SUBSURFACE WASTEWATER DISPOSAL SYSTEM APPLICATION

City, Town, or Plantation: AUGUSTA
Street or Road: BELGRADE ROAD
Subdivision, Lot #: CEVIC CENTER DRIVE APARTMENTS

SIDNEY H. GELLER TRUST
SITE PLAN - BUILDING #1 SEPTIC
 CIVIC CENTER DRIVE APARTMENTS
 BELGRADE ROAD
 AUGUSTA, MAINE

From: Steve Howell [SHowell@SWCole.com]
Sent: Friday, December 04, 2009 9:09 AM
To: George Soucy Jr.
Cc: Tim Hodgins
Subject: Emailing: Scan9221

SIDNEY H. GELLER TRUST
CROSS SECTIONS - BUILDING #1 SEPTIC
 CIVIC CENTER DRIVE APARTMENTS
 BELGRADE ROAD
 AUGUSTA, MAINE

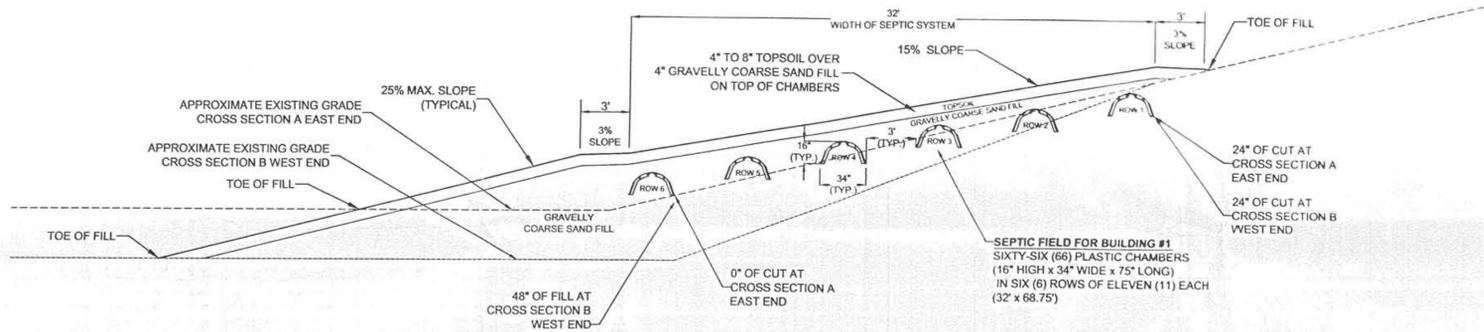
We were contacted by the contractor (McGee Construction) installing the 3 septic systems for Civic Center Drive regarding installation of A300 Zabel filters on the existing septic tanks. The contractor has determined that the existing tanks will not accommodate the A300 filter and that the tanks have the old-fashioned top of the tank hanging baffles. He is requesting that we eliminate the requirement for the A300 filter on the existing tanks. We feel this top hanging type of baffle will be effective at eliminating solids from the effluent and have agreed to eliminate the A300 filter requirement unless the existing tank or baffle is in poor condition and needs to be replaced.

Attached is a copy of page 1 for the three septic designs and the revised construction note page. Please let me know if you have any concerns or recommendations regarding this revision.

9. CONTRACTOR TO VERIFY LOCATIONS OF SEPTIC TANKS PRIOR TO CONSTRUCTION. ~~ALL TANKS TO BE REPLACED WITH A300 ZABEL FILTER EQUIVALENT PRODUCT.~~
10. WHERE EXISTING TANKS ARE REPLACED INSTALL RISERS, INSTALL A300 ZABEL FILTERS, AND USE HEAVY DUTY ONE PIECE TANK.
